## Ed Pentaleri

December 11, 2019

I am a resident and former selectman for the Town of Alna. My wife and I live in the Head Tide Historic district, where we have property with frontage on the Sheepscot River. I am writing in opposition to the NRPA permit for a boat ramp and dock that Jeff Spinney has applied for on the his property in Alna at tax map R-4, parcel 21A.

Figure 1: Distance to nearest comparable boat launch (Newcastle side).

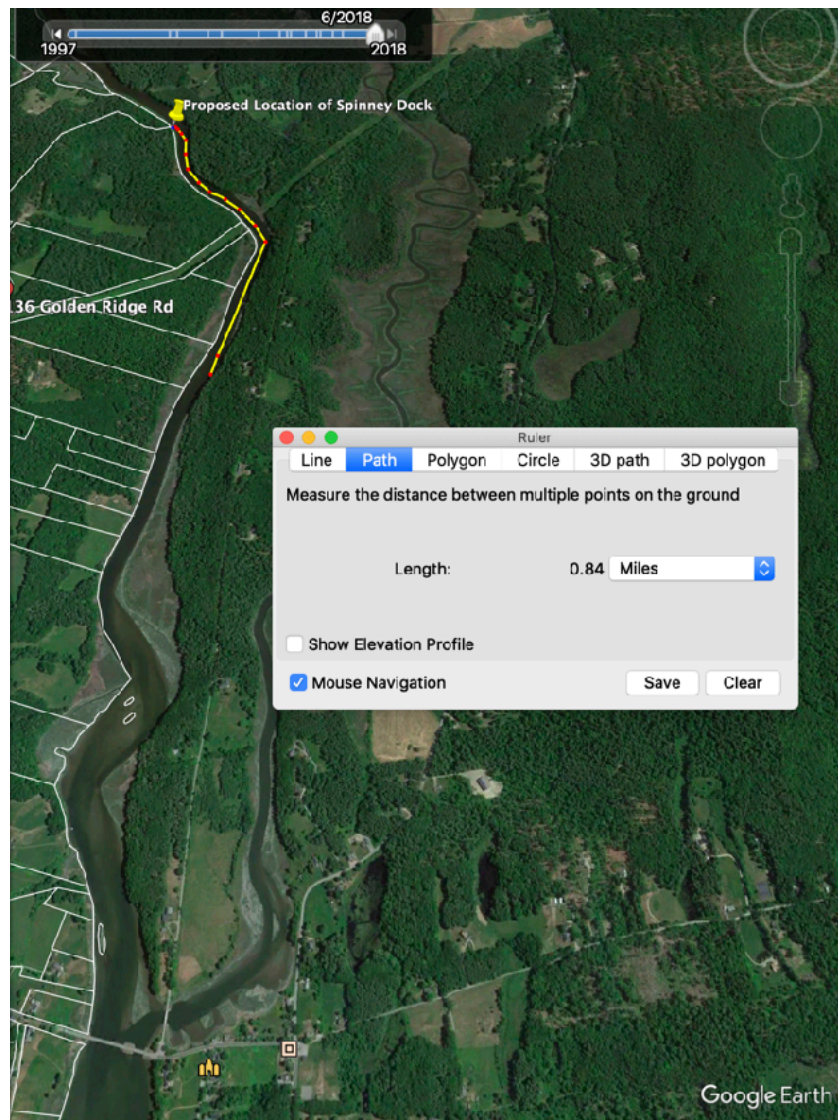
- (i) A satellite survey of the section of the river in question clearly shows that Mr. Spinney's previously permitted boat launching facility is nearly a mile above river from nearest comparable boat launch, located on the Newcastle side of the river, as shown in Figure 1. The nearest comparable boat launch on the Alna side of the river is approximately 1 1/4 miles downriver (Figure 2). While the extent to which the dock on the Newcastle side remains in current use is unclear, it is evident that the boat launch on the Alna side is principally, if not exclusively used for non-motorized watercraft.

Figure 3: Distance to Peele boat launch (near Sheepscot Village)

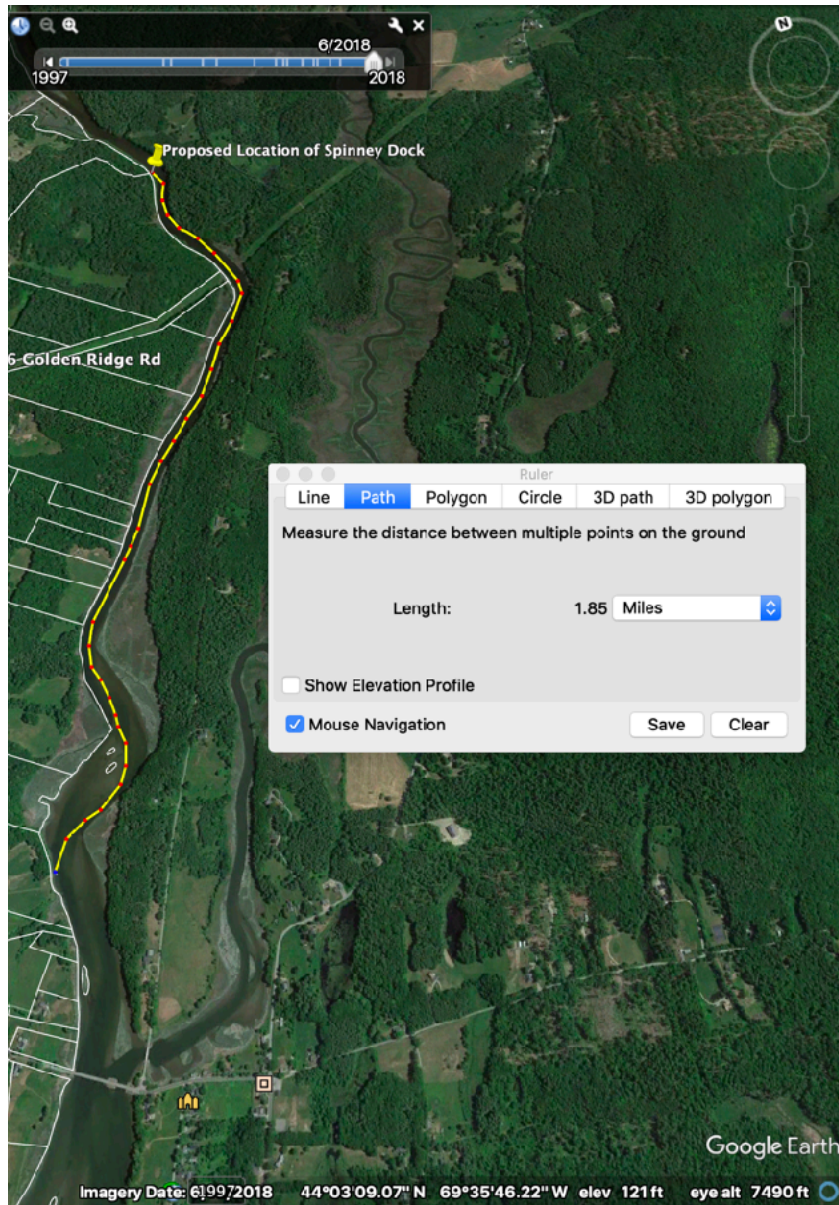
In fact, the nearest boat launching facility that appears to have any current use involving motorized watercraft appears to be nearly 2 miles downriver from the site of Mr. Spinney’s proposed dock/ramp, on the Peele property, approximately 1/4 mile from the bridge in Sheepscot Village (Figure 3). There are no such facilities located upriver from the site of Mr. Spinney’s proposed dock/ramp.

Figure 4: Distance to site of historic public boat launch in Sheepscot Village.

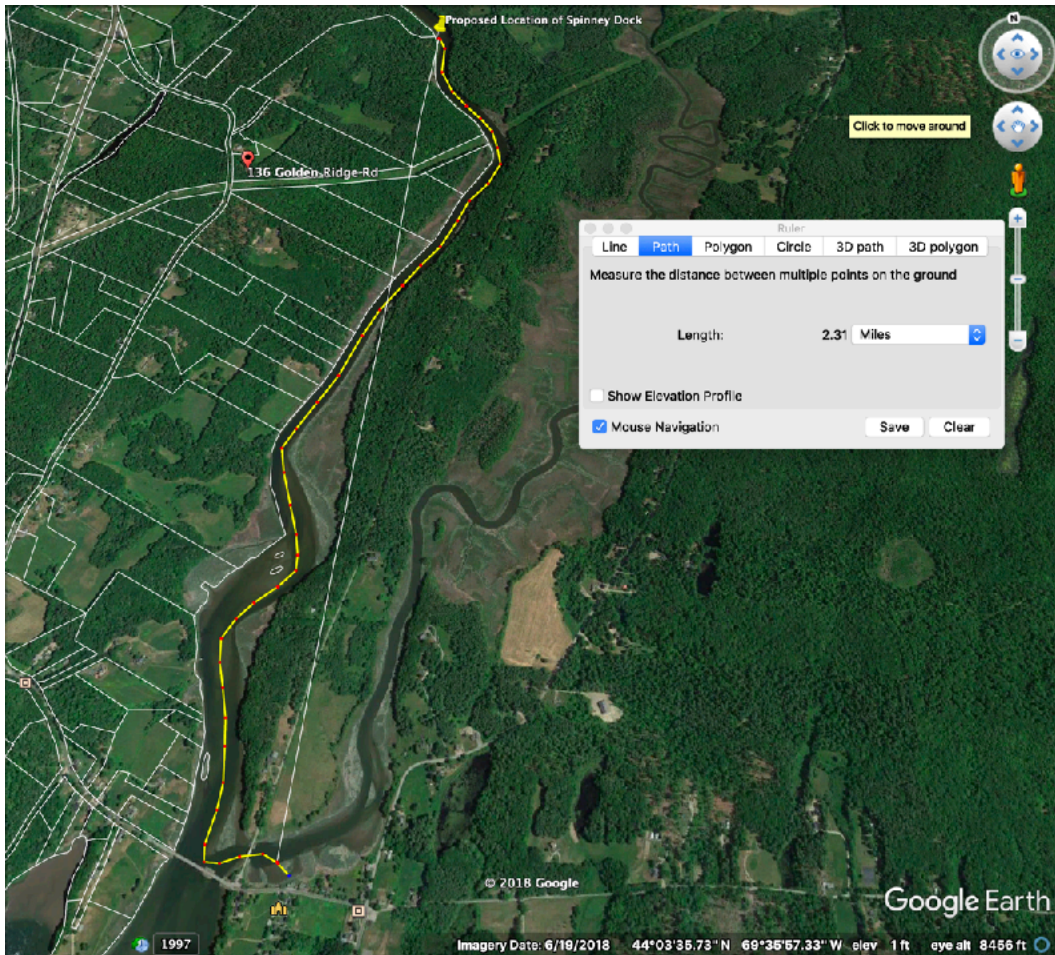
- (ii) After reading through numerous letters that have been submitted in support of Mr. Spinney’s application, the repeated reference to historical uses associated with motorized watercraft that once accessed the Sheepscot River at a launch site near the former location of the post office is noteworthy. While these represent somewhat interesting accounts of *historic* use of the the river, it is clear that such use ended many years, if not decades ago, and have no bearing whatsoever on *current* uses that must be considered in your review of the NRPA application. Furthermore, it is important to note that, even if these historic uses were pertinent to current uses, this launch site is located on the Dyer River, at a location that is approximately 2 1/3 miles downstream from Mr. Spinney’s proposed dock/ramp (Figure 4). The physical distance between the quiet and undeveloped section of river where Mr. Spinney proposes his dock/ ramp and the location much more developed site of the ramp that once existed in Sheepscot Village makes these historical accounts all the less relevant to the consideration of potential impacts upon current uses.
